PRODUCT/PROCESS CHANGE NOTICE (PCN)

PCN #: L-0607-01	DATE: 4-Aug-2006	MEANS OF DISTINGUISHING CHANGED DEVICES:
Product Affected: Please see the attached list of the affected products shipped in tape and reel and in tubes		<input type="checkbox"/> Product Mark <input type="checkbox"/> Back Mark <input checked="" type="checkbox"/> Date Code <input type="checkbox"/> Other
Date Effective: 4-Aug-2006		Lot shipments will have Level 1 Moisture Sensitive Label, and with date code "0630".

PCN Type: Change in Moisture Sensitivity Level

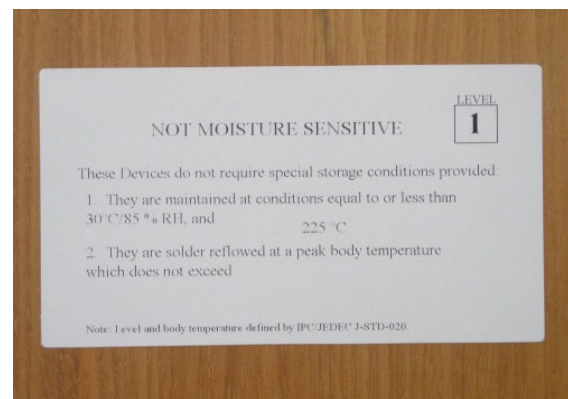
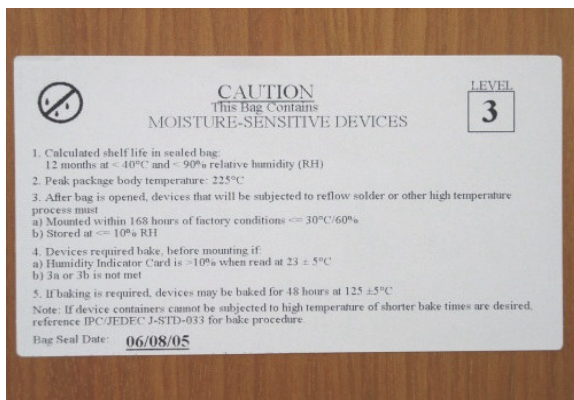
The affected products will be shipped without dry pack and labelled as MSL 1 according the JEDEC J-STD-033. There is no change to the assembly material set and the peak reflow temperature. Please refer below for the examples of moisture sensitive labels.

From: MSL 3 Moisture Sensitive Label

To: MSL 1 Non-Moisture Label
